**NEW YORK STATE THRUWAY AUTHORITY
DEPARTMENT OF ENGINEERING**

**AMENDMENT NO. 3
TO**

**CONTRACT TANY 26-17B
D215020
REPLACEMENT OF THE PINE HILL ROAD
BRIDGE OVER I-87 AT MP 47.58,
REHABILITATION OF I-87 BRIDGE OVER
SMITH CLOVE ROAD AT MP 47.04,
AND RESURFACING AND SAFETY IMPROVEMENTS
ON I-87 BETWEEN MP 46 AND MP 48
IN THE NEW YORK DIVISION
OF THE NEW YORK STATE THRUWAY
IN ORANGE COUNTY**

DRAWING NUMBER:
ST-04

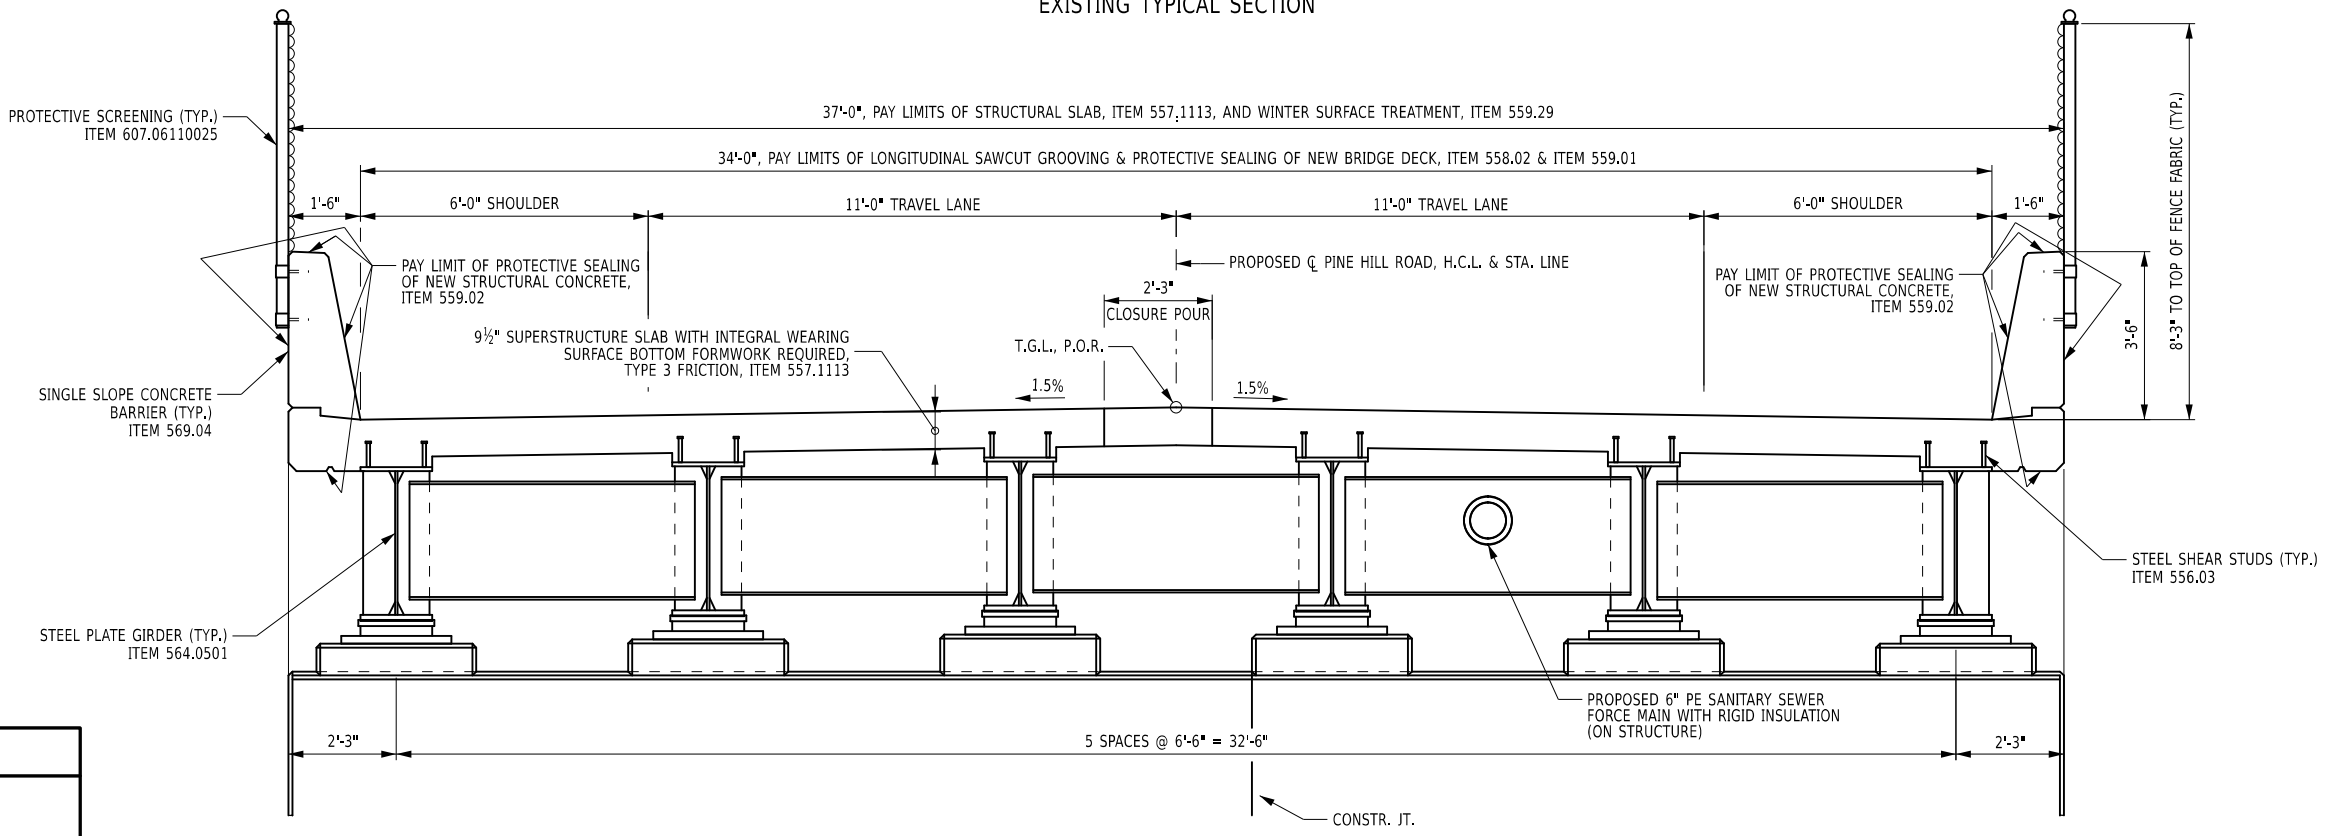
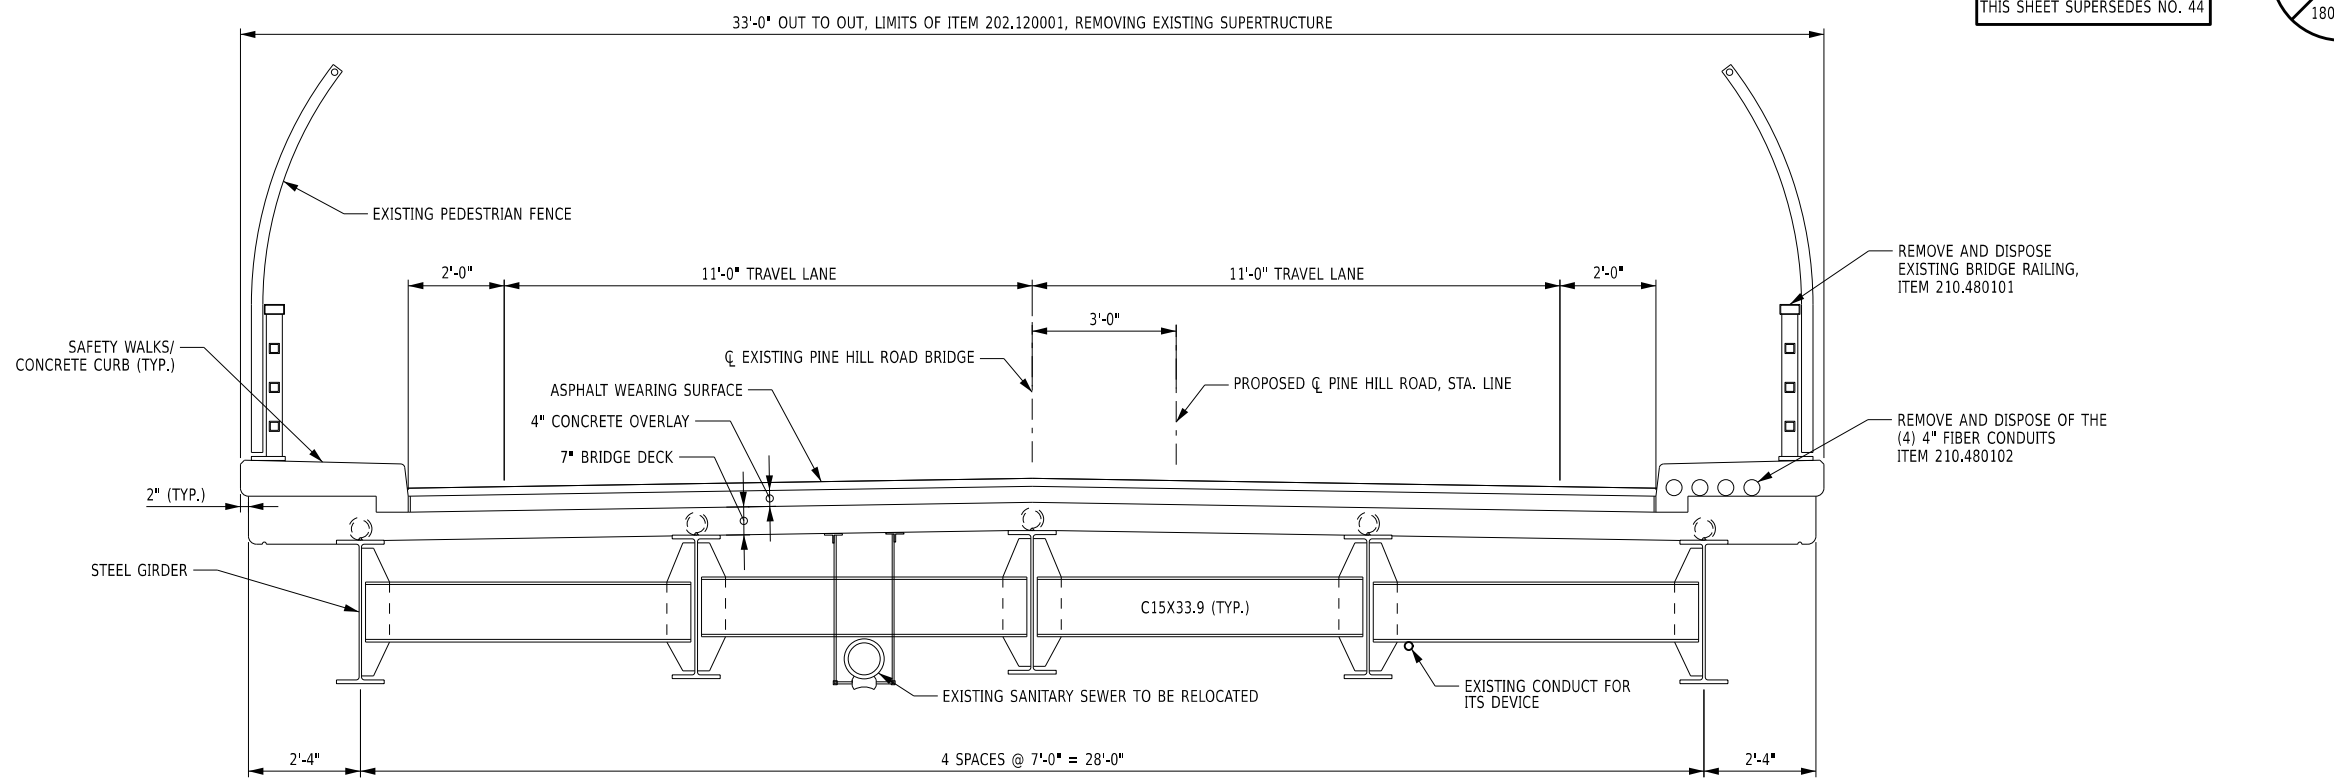
8. **DELETE** Drawing Number ST-04, Sheet 44 of 180, and **SUBSTITUTE** with the attached Drawing Number ST-04, Sheet 44A3 of 180. Previous ITS conduit callout has been removed, and the callouts to the pay limits for Protective Sealing of Structural Concrete have been updated in the Proposed Typical Section detail.

CONTRACT NUMBER: TANY 26-17B
 DATE: 01/19/2026
 DRAWING NUMBER: ST-25

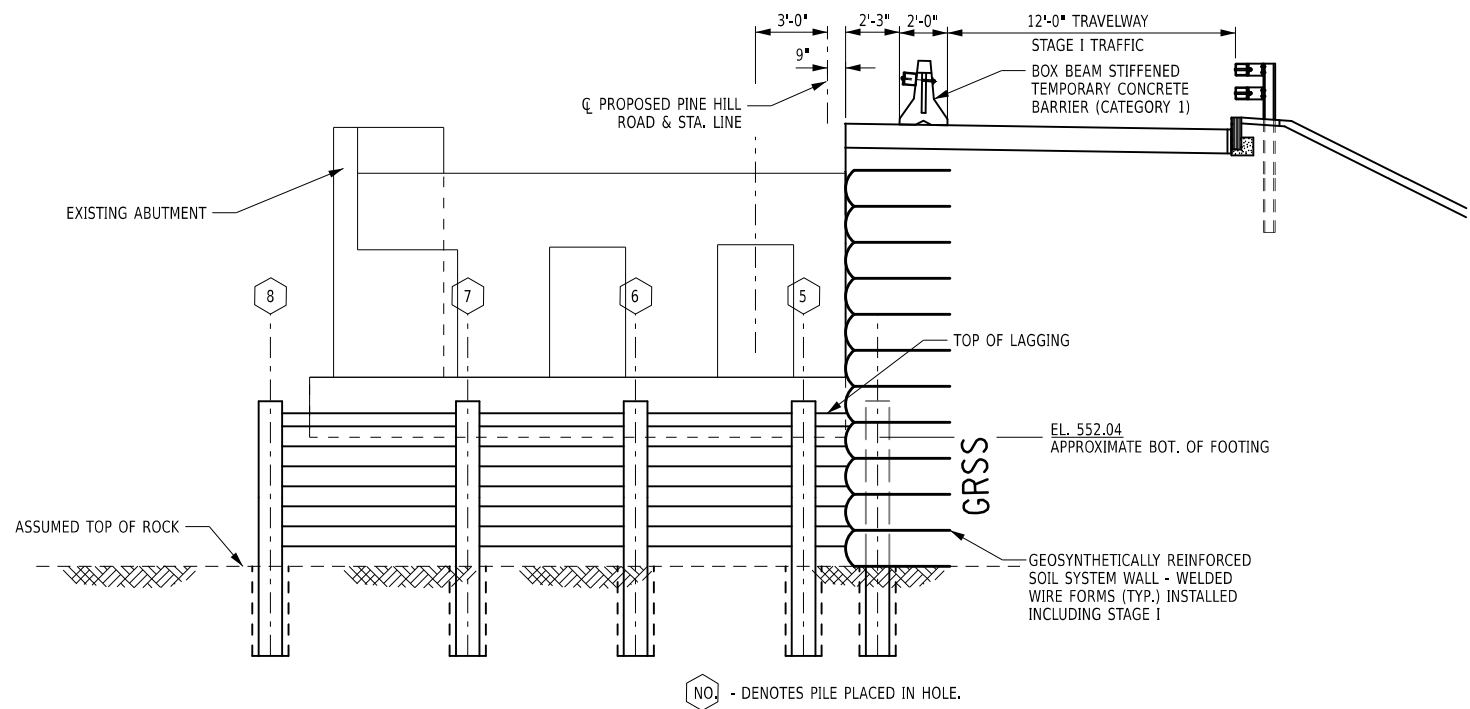
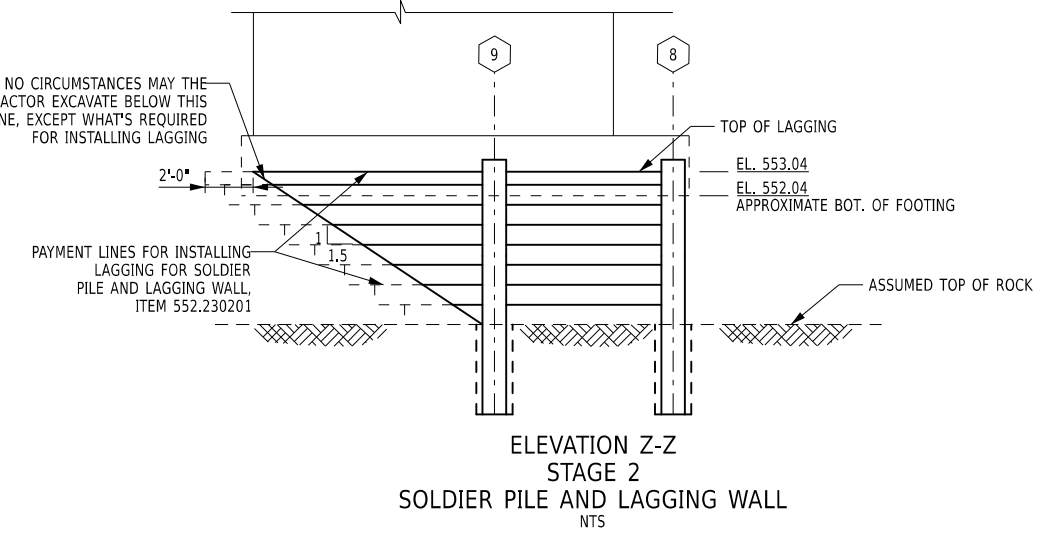
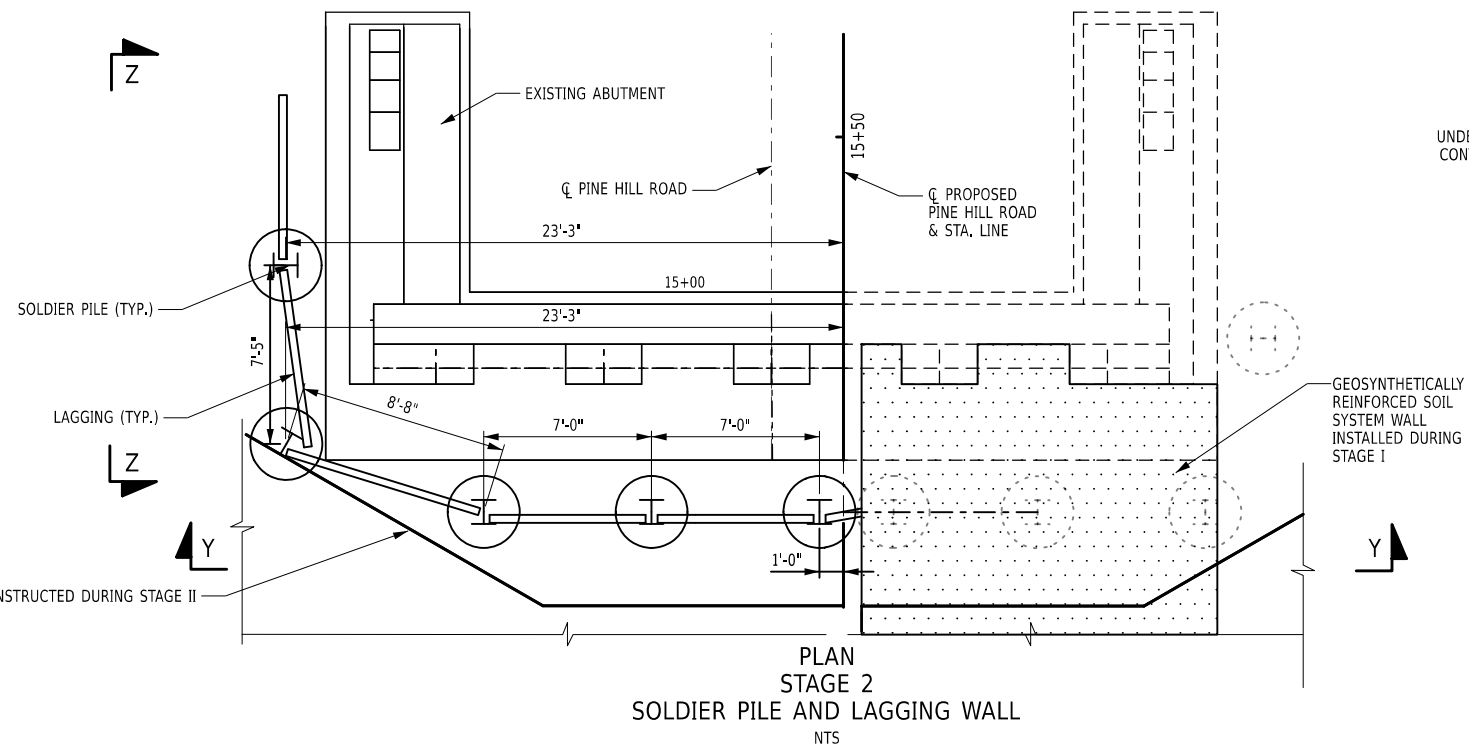
9. **DELETE** Drawing Number ST-25, Sheet 65 of 180, and **SUBSTITUTE** with the attached Drawing Number ST-25, Sheet 65A3 of 180. Note 5 has been removed.

TITLE OF PROJECT REPLACEMENT OF THE PINE HILL ROAD BRIDGE AT I-87 MILEPOST 47.58	CONTRACT NUMBER: TANY 26-17B
LOCATION OF PROJECT VILLAGE OF WOODBURY ORANGE COUNTY BIN 5514280	DATE: 01/19/2026
TITLE OF DRAWING TRANSVERSE SECTION	DRAWING NUMBER: ST-43

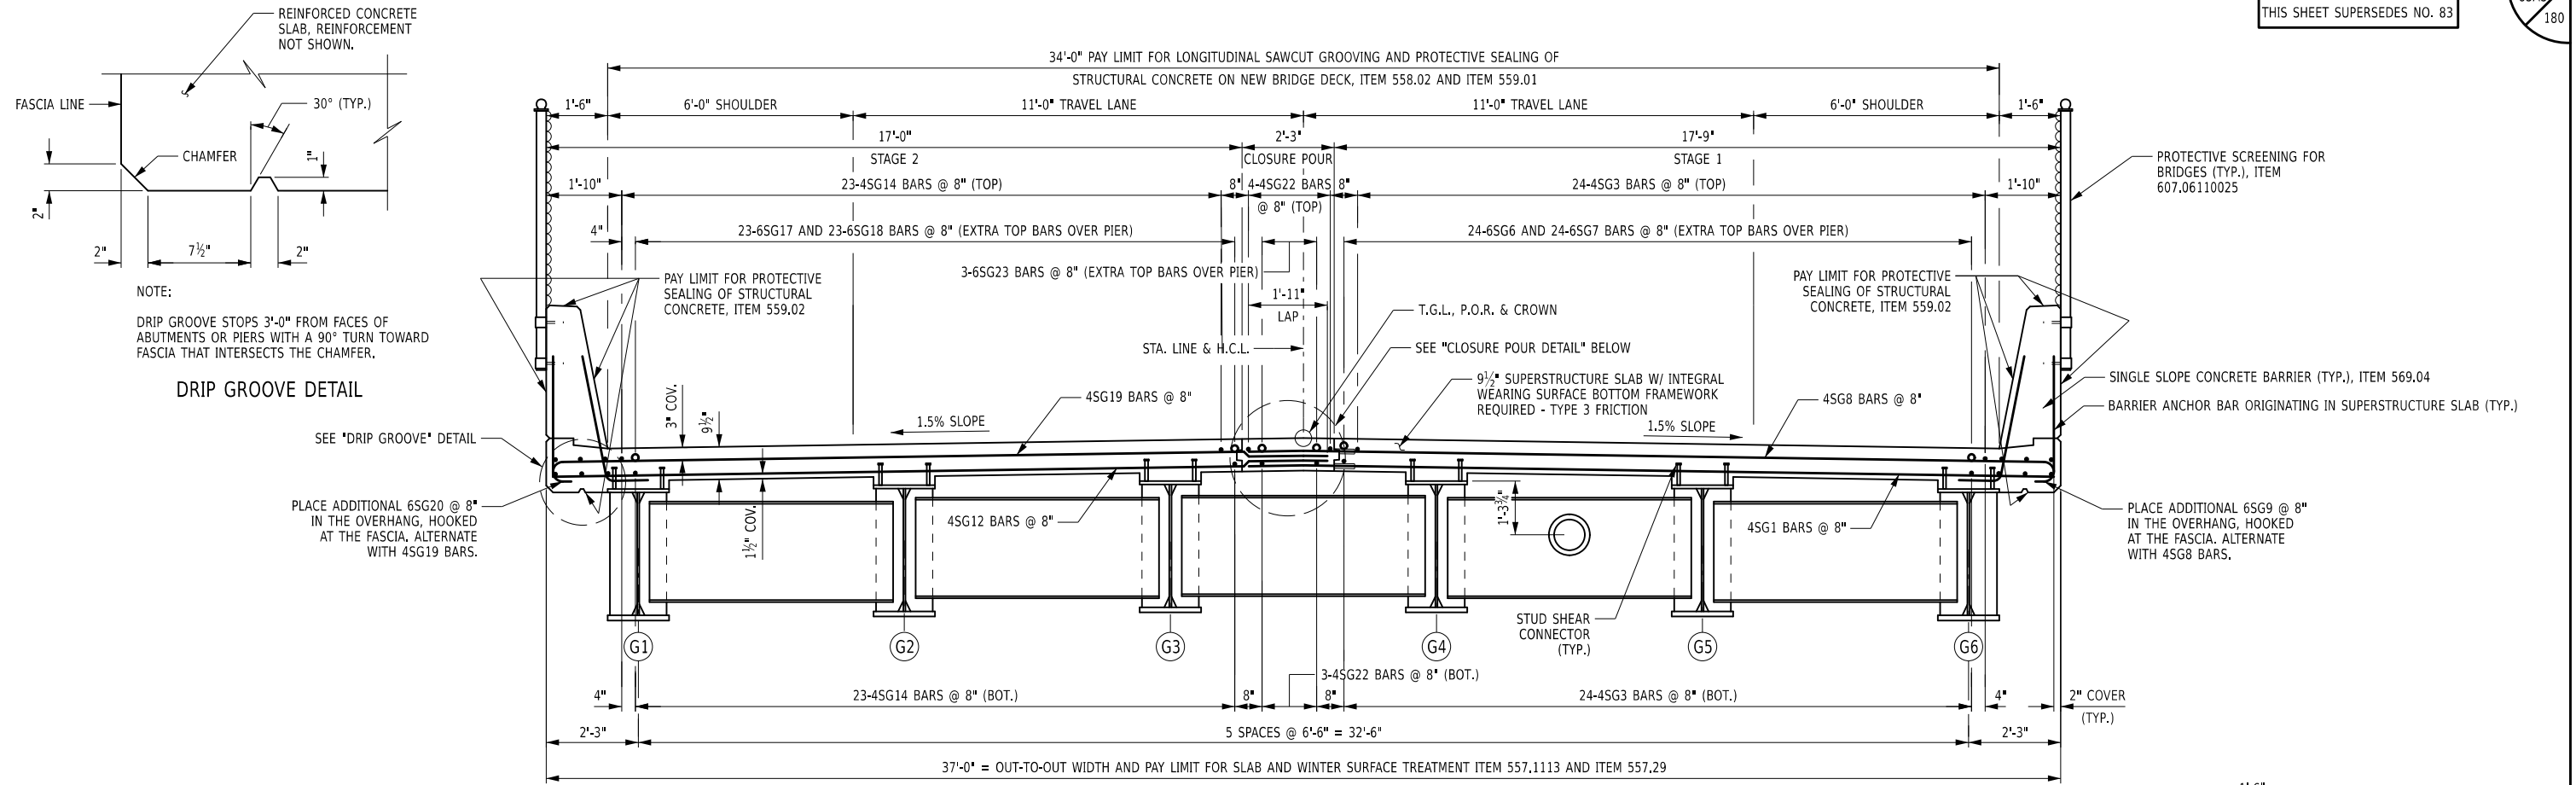
10. **DELETE** Drawing Number ST-43, Sheet 83 of 180, and **SUBSTITUTE** with the attached Drawing Number ST-43, Sheet 83A3 of 180. The callouts to the pay limits for Protective Sealing of Structural Concrete have been updated in the Transverse Section detail.

TITLE OF PROJECT REPLACEMENT OF THE PINE HILL ROAD BRIDGE AT I-87 MILEPOST 47.58	CONTRACT NUMBER: TANY 26-17B
	LOCATION OF PROJECT VILLAGE OF WOODBURY ORANGE COUNTY BIN 5514280	DATE: 01/19/2026
TITLE OF DRAWING FRAMING PLAN		DRAWING NUMBER: ST-44

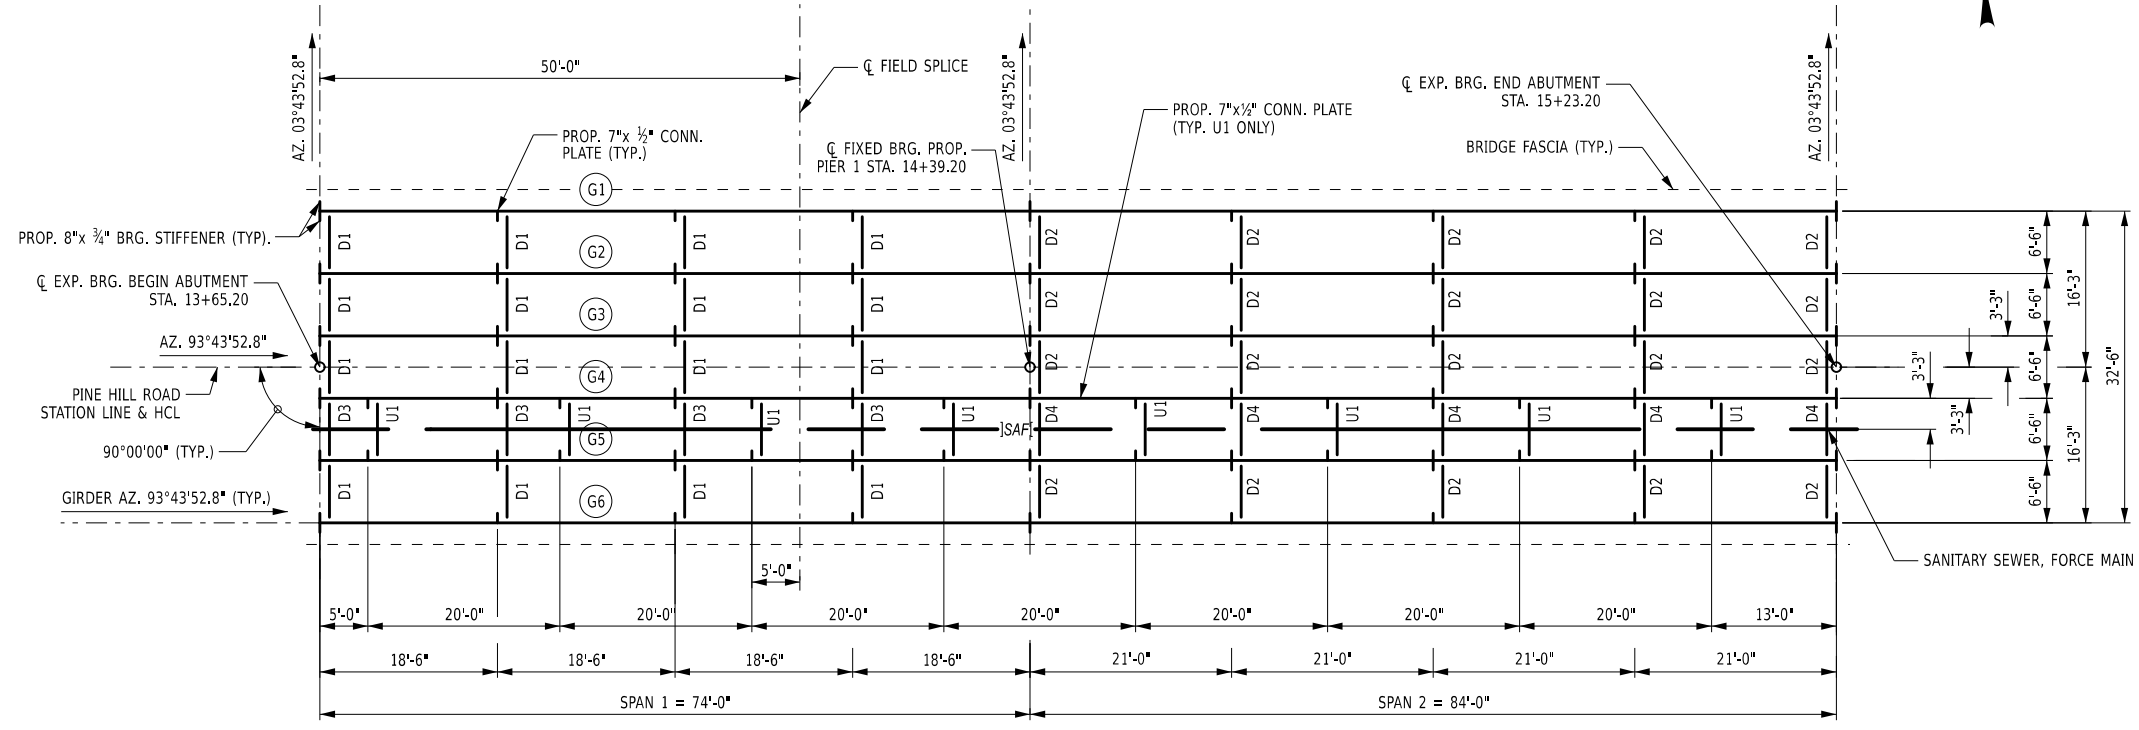
11. **DELETE** Drawing Number ST-44, Sheet 84 of 180, and **SUBSTITUTE** with the attached Drawing Number ST-44, Sheet 84A3 of 180. The previous callout of the ITS Antenna Support has been removed from the Framing Plan detail.
